Subject: Beaver Valley Power Station, Unit No. 1
Docket No. 50-334, License No. DPR-66
License Amendment Request No. 293

Subject: **Beaver Valley Power Station, Unit No. 1**
BV-1 Docket No. 50-334, License No. DPR-66
License Amendment Request No. 293

Beaver Valley Power Station, Unit No. 1
License Amendment Request No. 293

Beaver Valley Power Station, Unit No. 1
License Amendment Request No. 293
REVISION OF RCS SPECIFIC ACTIVITY VALUE

FIGURE 3.4-1
DOSE EQUIVALENT I-131 Primary Coolant Specific Activity Limit
Versus Percent of RATED THERMAL POWER with the Primary
Coolant Specific Activity > ~~0.20~~ μCi/gram DOSE EQUIVALENT I-131

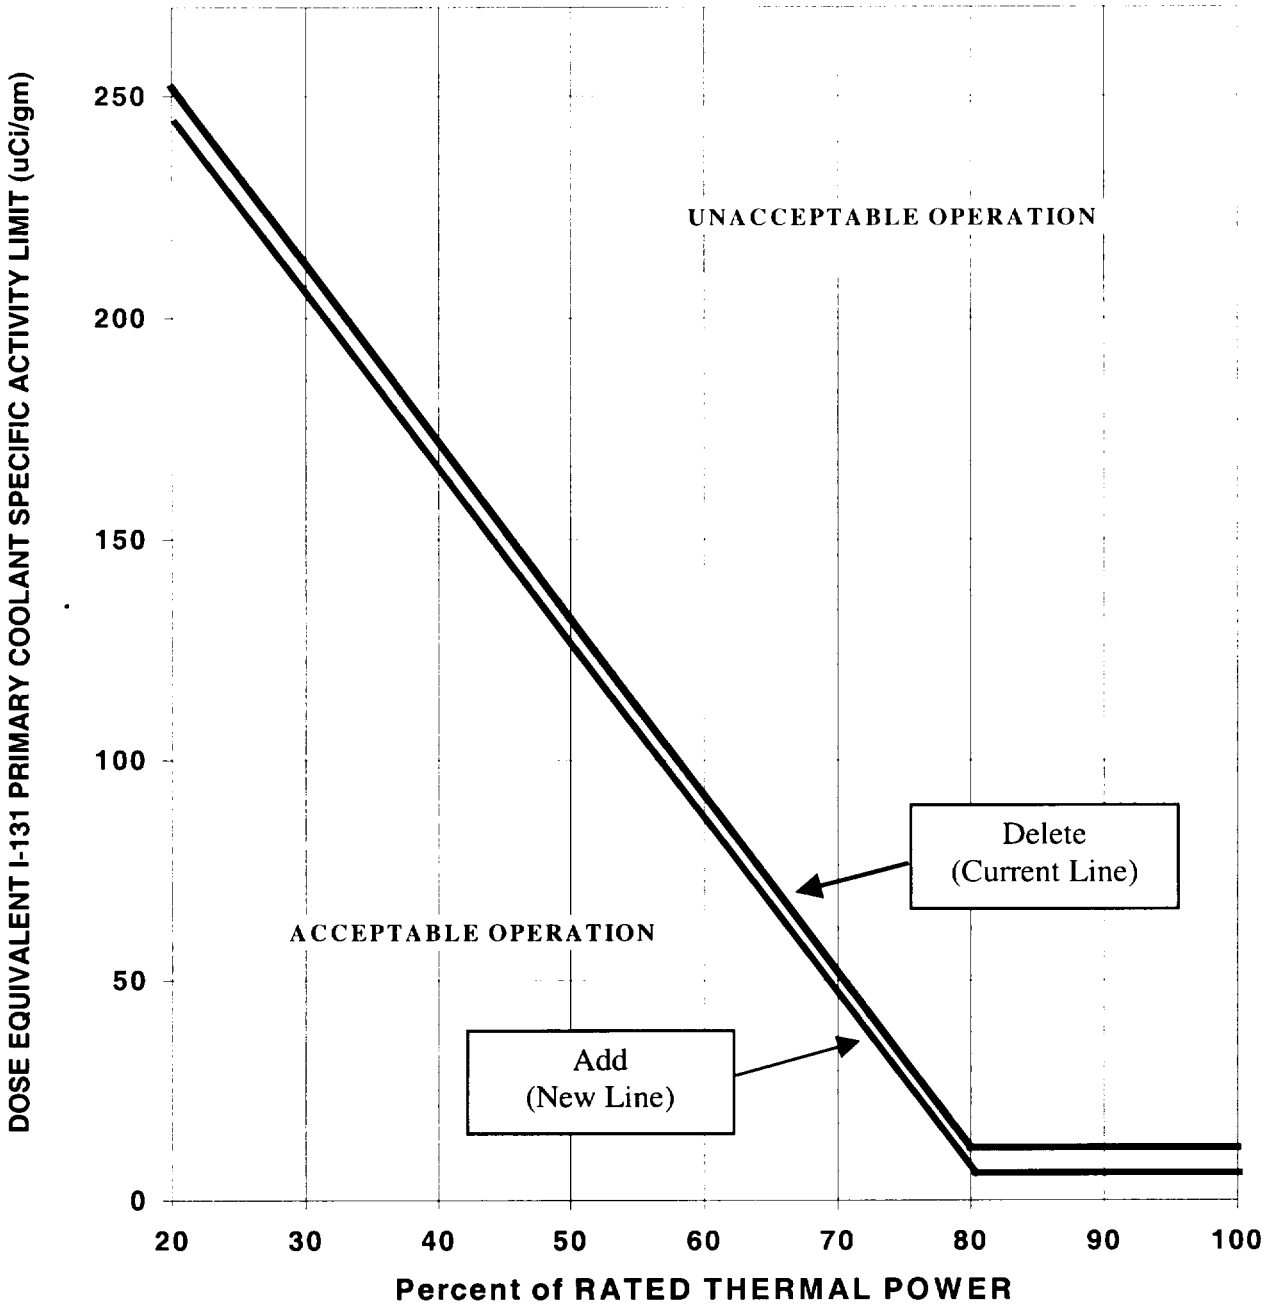
a. With the specific activity of the primary coolant > ~~0.20~~ 0.10 μCi/gram DOSE EQUIVALENT I-131 for more than 48 hours during one continuous time interval or exceeding the limit line shown on Figure 3.4-1, be in HOT STANDBY with Tavg < 500°F within 6 hours.

0.10

a. ≤ ~~0.20~~ 0.10 μCi/gram DOSE EQUIVALENT I-131, and
